TECHNICAL BULLETIN
Bell Helicopter

No. 407-07-80

SUBJECT: PITCH HORN 407-010-103-113, REPAIR OF.

HELICOPTERS AFFECTED: Model 407 helicopters serial number 53000 through subsequent.

Figure 1. Pitch horn assembly repair limits

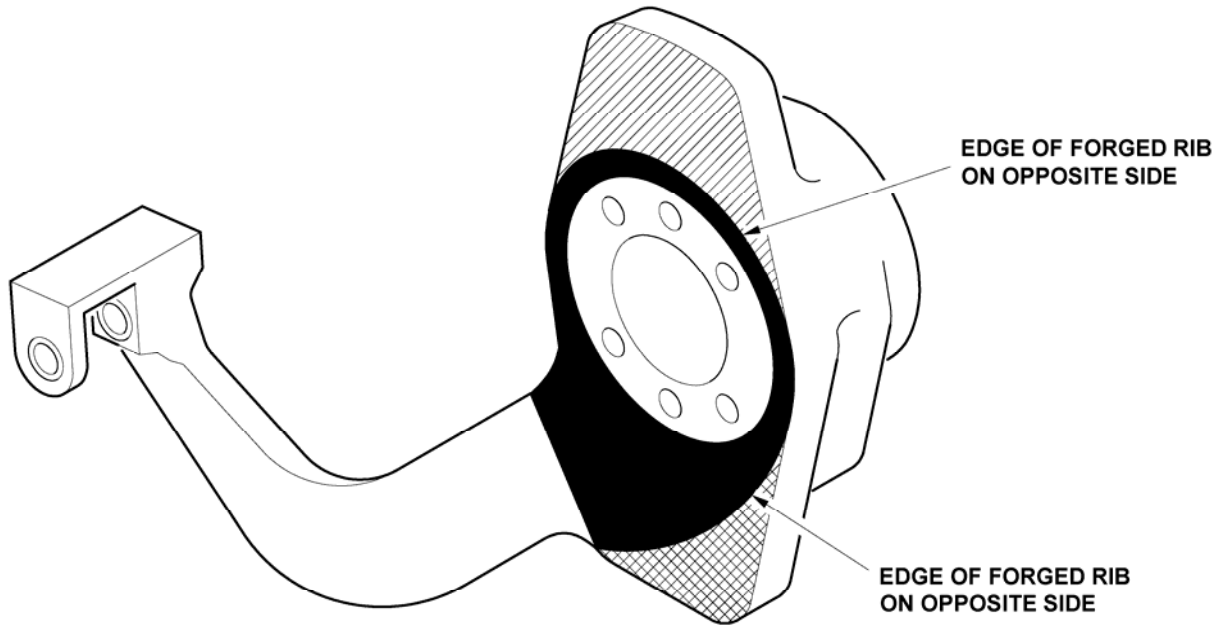
1. Refer to Figure 1 and evaluate if the repair provided herein can be accomplished.
2. If the corrosion damage does not exceed the repair limits given on Figure 1, proceed with step 3. If the corrosion damage exceeds the limit given on Figure 1, proceed with Part III.
3. Remove the 407-010-103-113 pitch horns from the main rotor hub assembly. Refer to BHT-407-CR&O, Chapter 62.

- c. Measure the depth from the tungsten carbide surface to the bottom of the cut after removing the corrosion from the aluminum. If the depth exceeds the repair limits given on Figure 1, proceed with Part III.

- j. Repeat steps 3.a. through 3.i. for other areas indicating corrosion. Quantity of repairs is limited as shown in Figure 1. There must be also a minimum of 0.150 inch space between the edges of adjacent repair circles.

MAXIMUM REPAIR DEPTH			
CORROSION	0.015 inch (0.381 mm)	0.040 inch (1.016 mm)	NO CORROSION DAMAGE ALLOWED	 
NUMBER OF REPAIRS	FOUR	TEN	NO CORROSION DAMAGE ALLOWED

-  There must be a minimum of 0.150 inch (3.81 mm) space between the edges of adjacent repair circles.
-  Measure the depth from the tungsten carbide surface.
-  Limits are for corrosion removal prior to Part 1, step 3d.
